CITY OF SUPERIOR
C. Reiss Dock
RFQ #23-17-PL

ADDENDUM #5

DATE: April 28, 2023

This addendum modifies the Proposal Documents for the above listed project. The addendum consists of 63 pages.

SHEET NUMBER
C2.02

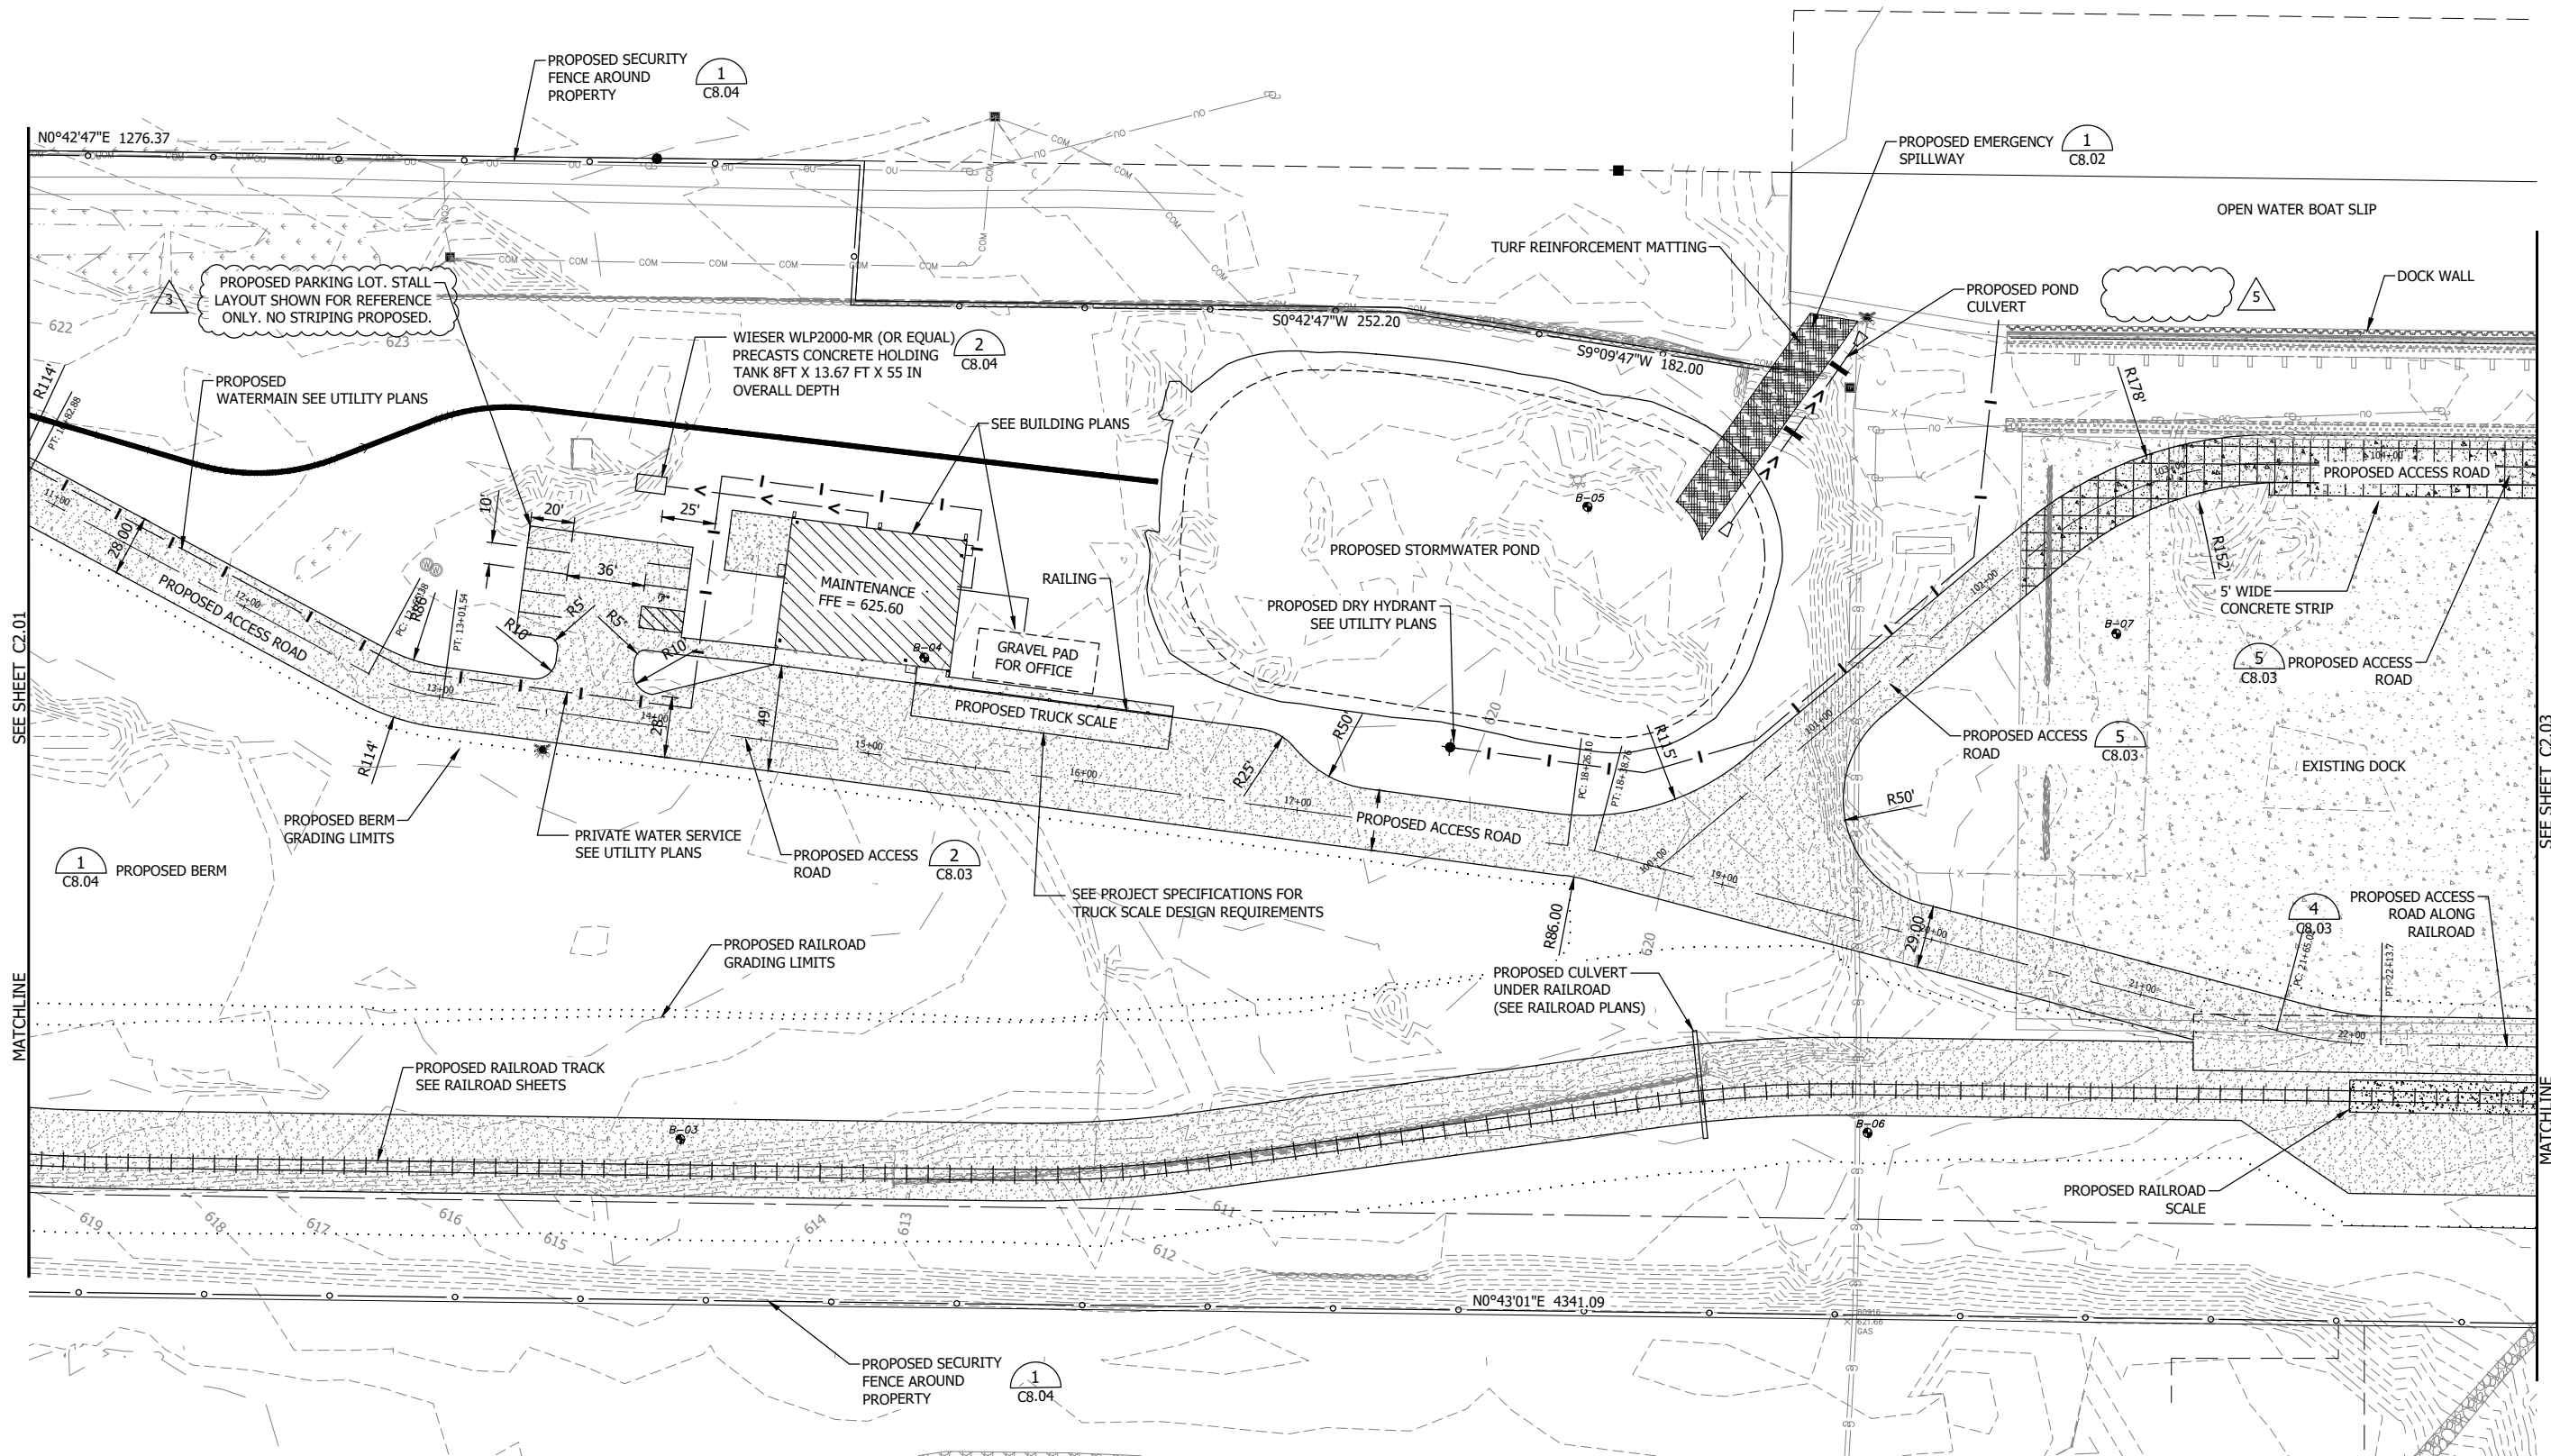
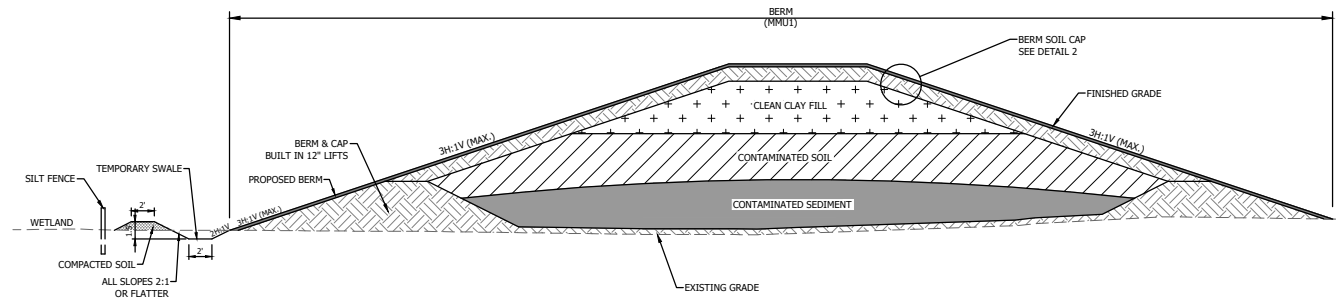
13. Q: There is a note on C2.02 for a Railing at the Truck Scale. Please clarify what is expected here. Location of railing, length, height, material type, etc.

14. Q: On C2.02 a Proposed Pump House is mentioned. Please confirm if this is to be included in this project? If so, provide details.

A: Such information with site plan showing final location and details for the scale and other necessary equipment location, shall be furnished by the contractor, distributor, or installer for review prior to commencement of construction.

A: This note has been removed from Sheet C2.02.

4 DRY HYDRANT
NTS
C4.02

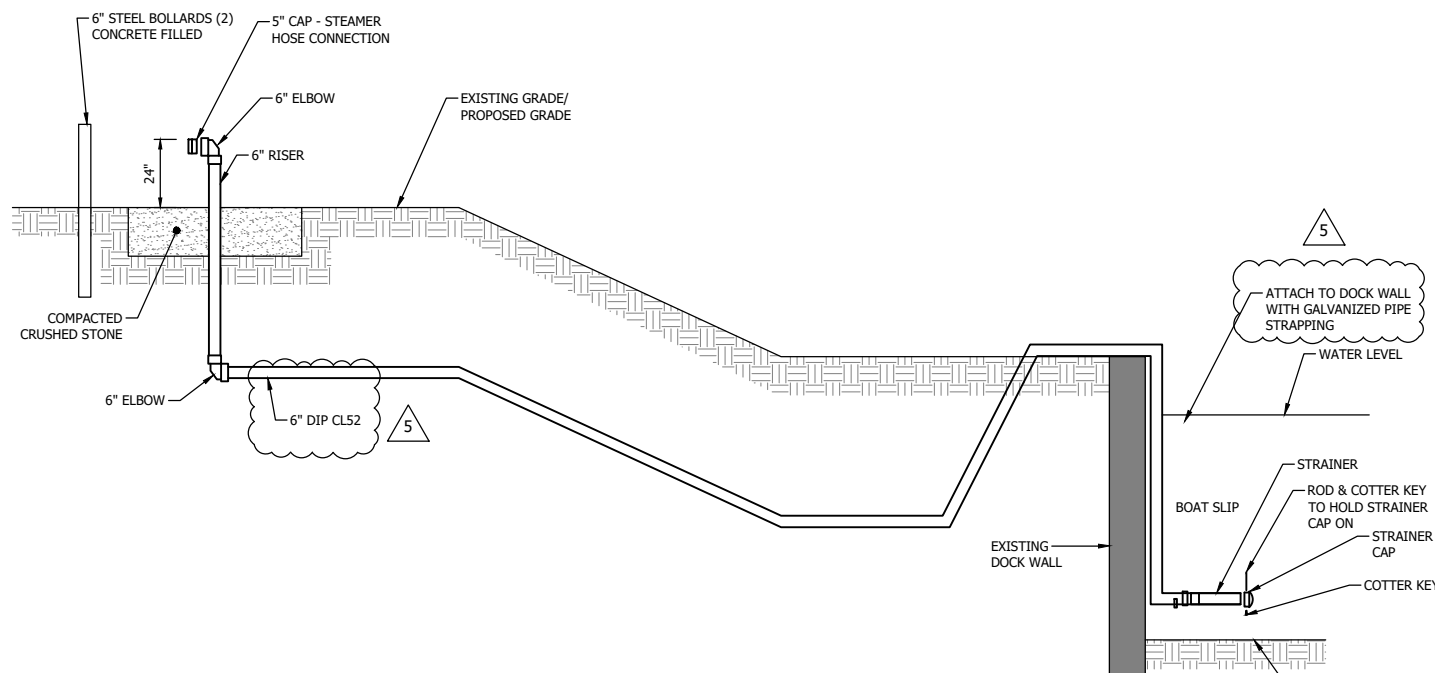
Plan Sheet – C-402

1. Dry hydrant profile has been revised (change in material)

DATE OF ISSUANCE	MARCH 10, 2023	
NO.	REVISION	DATE
3	ADDENDUM	4-18-23
4	ADDENDUM	4-26-23
5	ADDENDUM	4-27-23
SURVEY JIN		
DRAWN AJR		
DESIGNED AJR		
CHECKED AJR		
APPROVED AJR		
PROJ. NO.	193707141	
SHEET NUMBER	C8.01

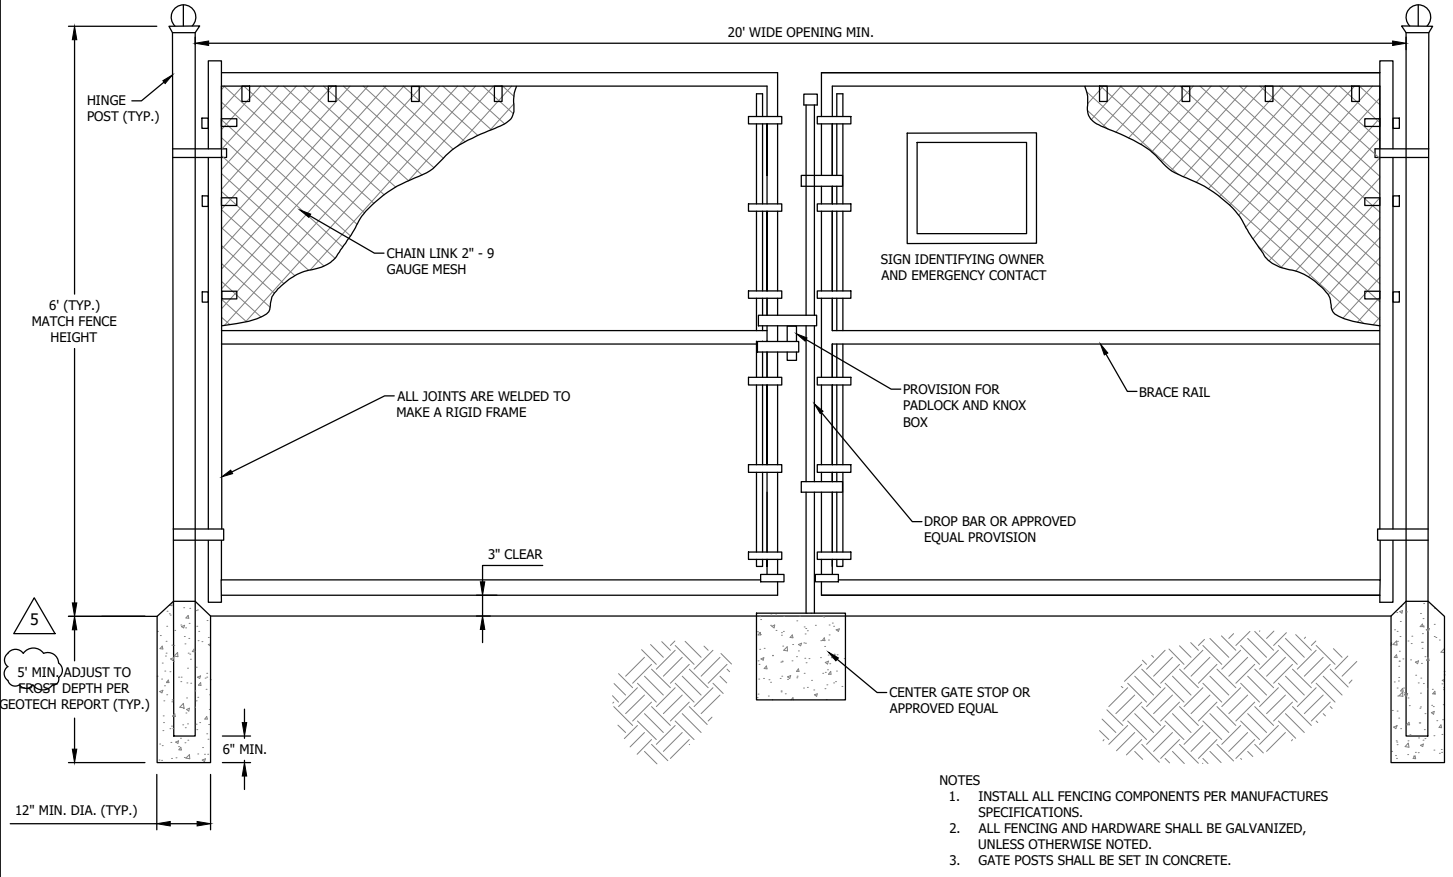
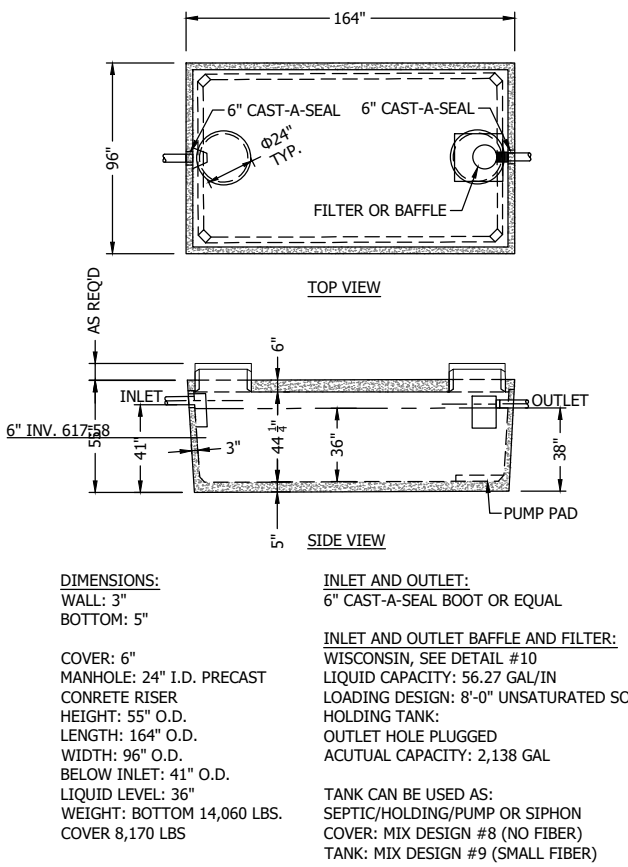
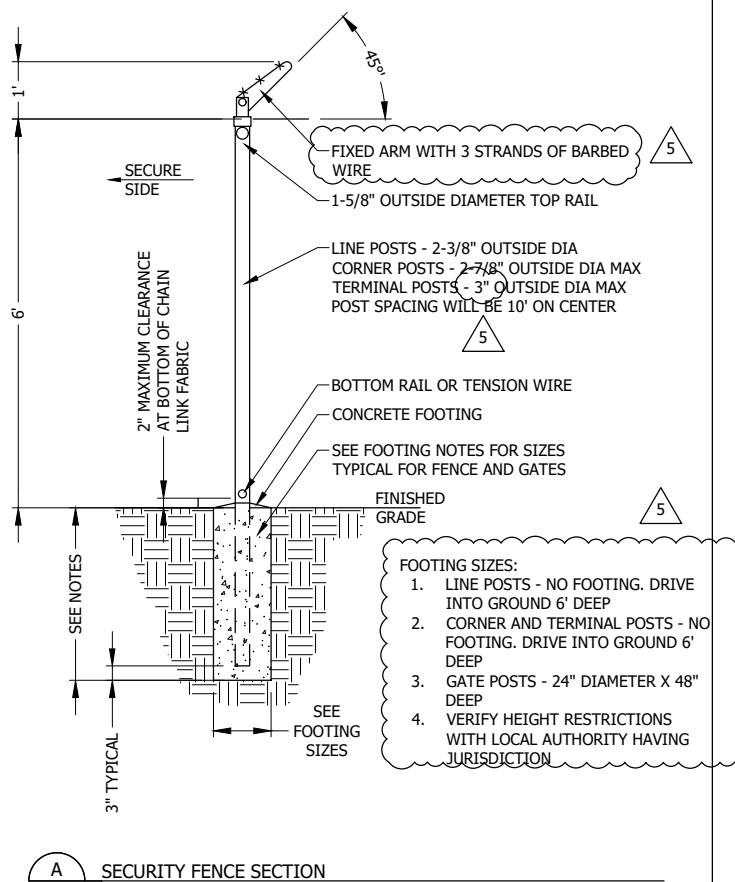
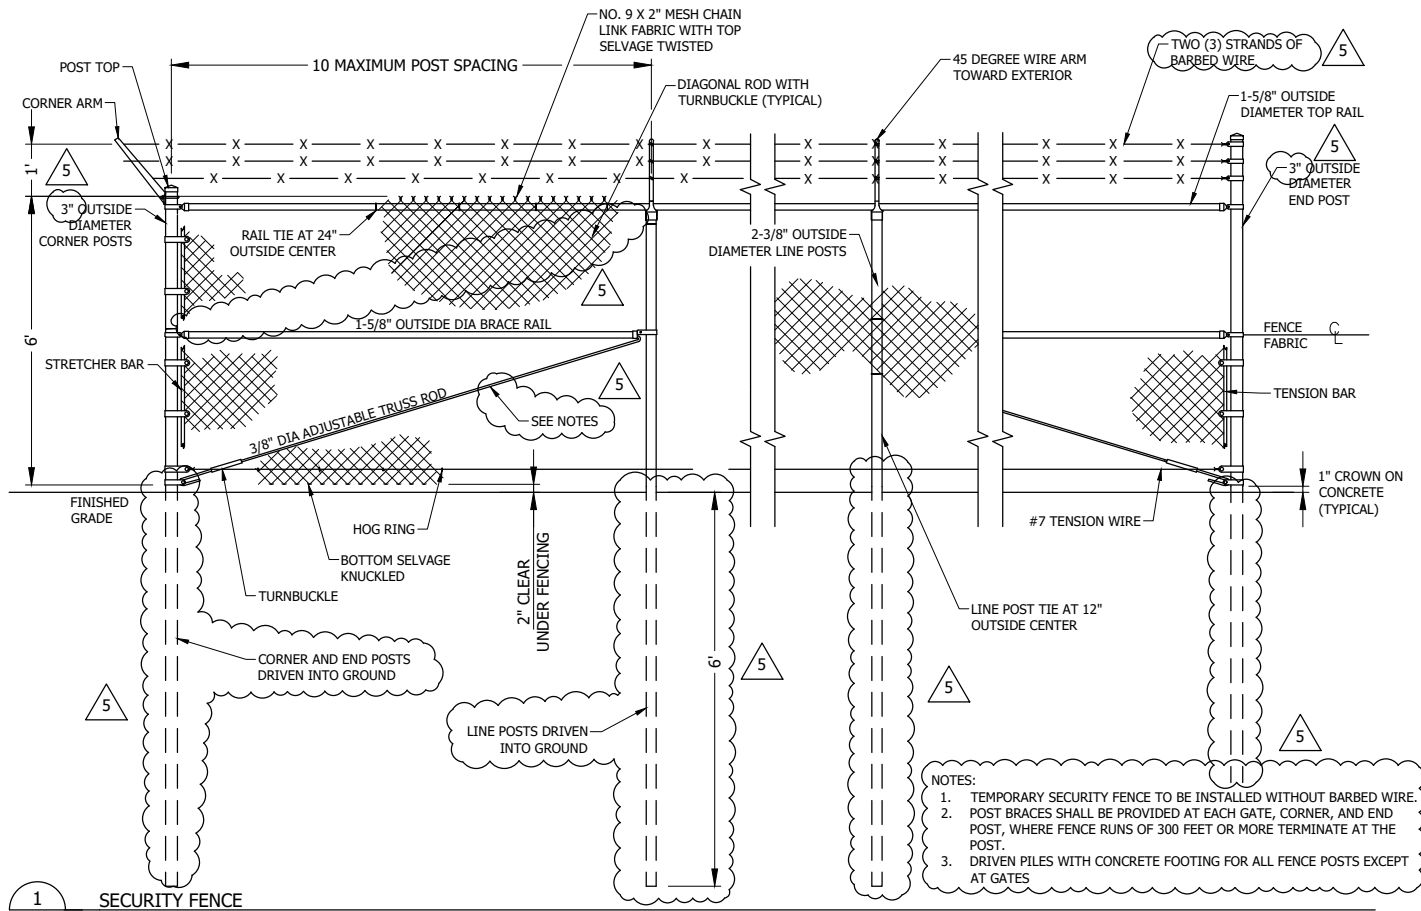
Plan Sheet – C-801

1. Detail 4 has been revised.
